**BEFORE THE PUBLIC UTILITY COMMISSION  
OF OREGON**

**LC 43**

In the Matter of PORTLAND GENERAL ELECTRIC 2007 Integrated Resource Plan	Reply Comments of Portland General Electric Company
--	--

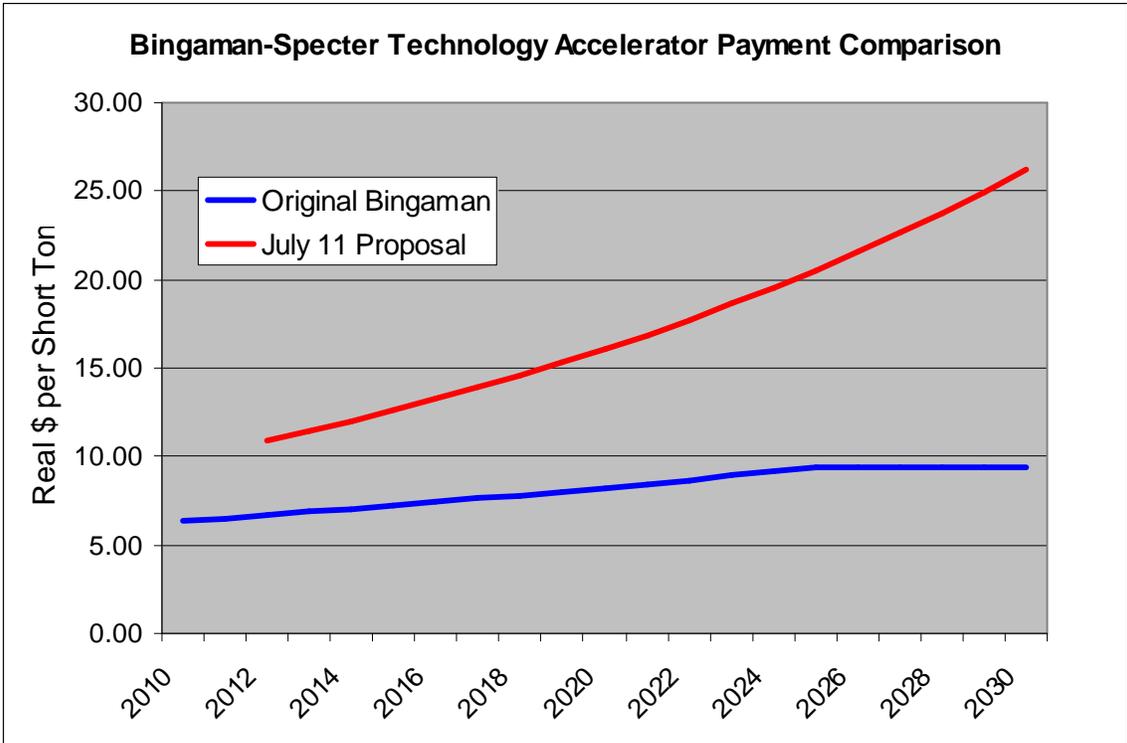
RNP asserts that PGE's IRP does not reflect the "current" policy environment for assumed base case CO<sub>2</sub> adder values. On July 11, 2007, Senators Bingaman and Specter introduced an updated federal CO<sub>2</sub> proposal, the Low Carbon Economy Act of 2007. This occurred after we finalized our IRP submittal. The revised approach was immediately endorsed by the National Commission on Energy Policy. PGE also endorses the July 11 proposal. In mid-June, we were aware that a new legislative proposal was being developed, as indicated on page 91 of our 2007 IRP, submitted on June 29. However, we were unsure at that time what provisions and prices the final legislative proposal would contain. Thus, PGE's analysis was current at the point of IRP publication, based on legislation that PGE publicly endorsed in December 2006 (see PGE's IRP, page 91). With respect to the base case CO<sub>2</sub> adder, RNP's assertion that "PGE acknowledges that this value is based on an out-of-date cap-and-trade policy" is incorrect.

The new legislative proposal increased the initial safety valve price (now called a Technology Accelerator Payment) from \$7 per metric ton in \$2010 to \$12 per metric ton in \$2012. It also increased the annual escalation from a 5% per year nominal increase to 5% a year above the rate of inflation. The year-to-year increase continues indefinitely in the July 11 proposal, whereas in the original proposal the price no longer changed after 2025. The cumulative effect of these changes is to approximately *double* the real levelized cost of the tax during our 2012 to 2031 study period. Hence, the new proposal represents a substantive increase. The following graph illustrates the safety valve pricing of the original vs. the July 11 proposal:

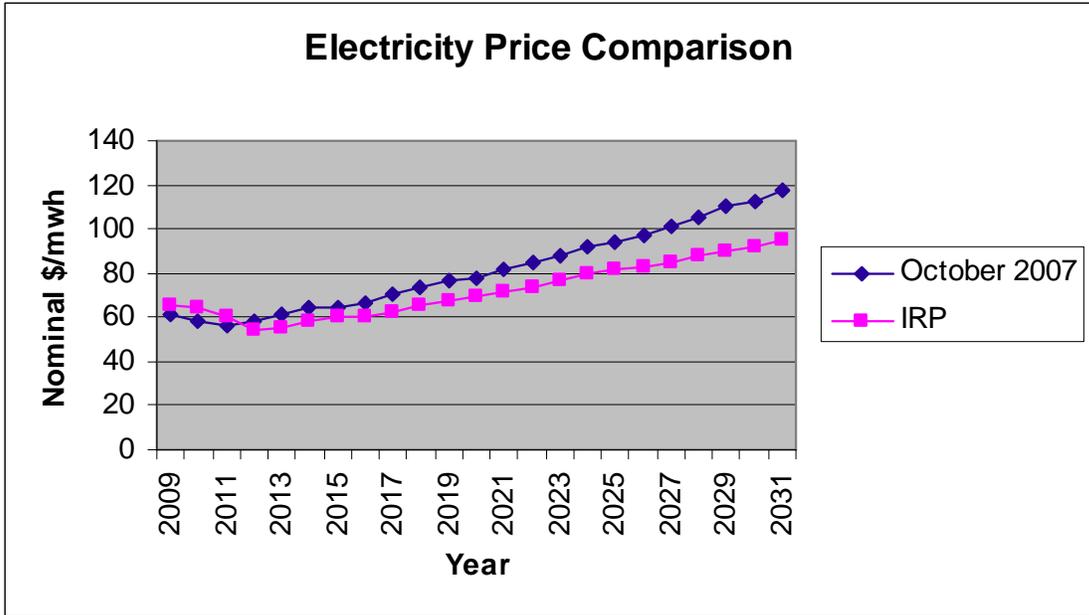
We have subsequently updated our deterministic analysis to incorporate the July 11 Bingaman-Specter proposal, using the \$12 per metric ton CO<sub>2</sub> adder in 2012, growing at 5% above the rate of inflation. In preparing this study, we also updated natural gas prices to reflect the most recent PIRA forecast. The updated gas prices for Sumas are approximately \$.65/mmbtu higher on a real levelized basis (2012-2020) than the prices used in the IRP.

In addition, we created a new WECC economic long-term expansion similar to that described in chapter 10 of our IRP. This allows us to establish new WECC-wide electricity prices based on higher gas prices and a modified resource expansion. The impact on electricity prices is shown below:

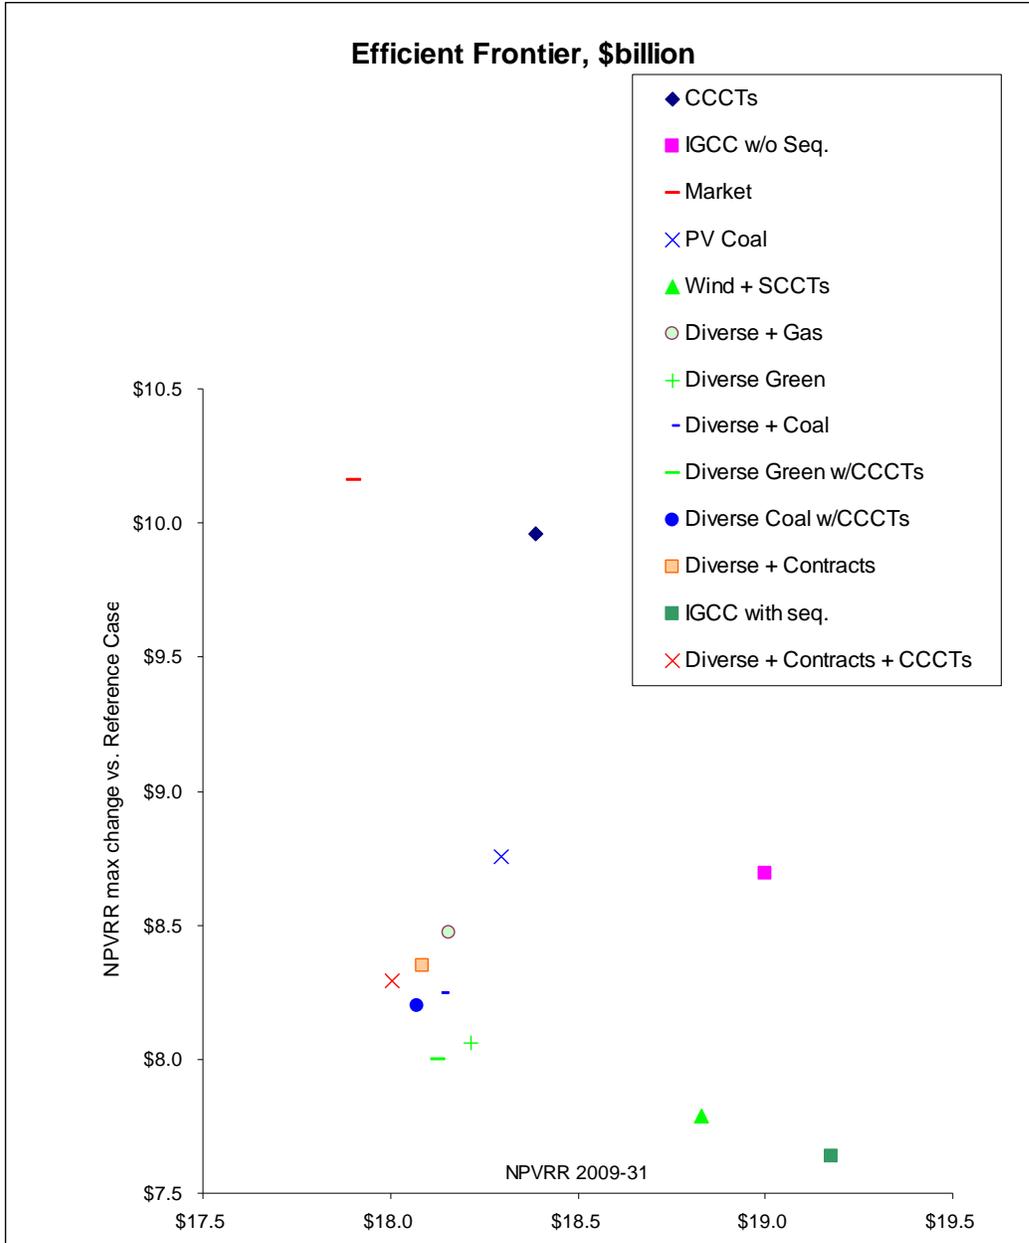
The result of the higher gas prices and higher CO<sub>2</sub> cost are shown in the Efficient Frontier graph shown below:

When compared to Figure ES-3 on Page 9 of the Executive Summary of our Integrated Resource Plan, there is no material difference in the relative performance of the portfolios. The portfolios, reflecting higher prices, increase in cost by approximately \$1.0 billion on average. The efficient frontier is also now more bowed – that is, portfolios that do not rely heavily on fossil fuels are less affected, whereas portfolios that are fossil fuel-heavy become more affected.<sup>2</sup> Portfolios that emphasize renewables perform somewhat better. After conducting this updated analysis, our preferred portfolio

remains unchanged. Two factors explain why this decision does not change. First, our proposed Action Plan does not rely on new coal or long-term gas in the first place. This update reinforces our original conclusion that our proposed Action Plan hedges reasonably well against CO<sub>2</sub> risk. Second, the Bingaman-Specter proposal is not so high as to cause dramatic changes in the expected dispatch of existing resources.
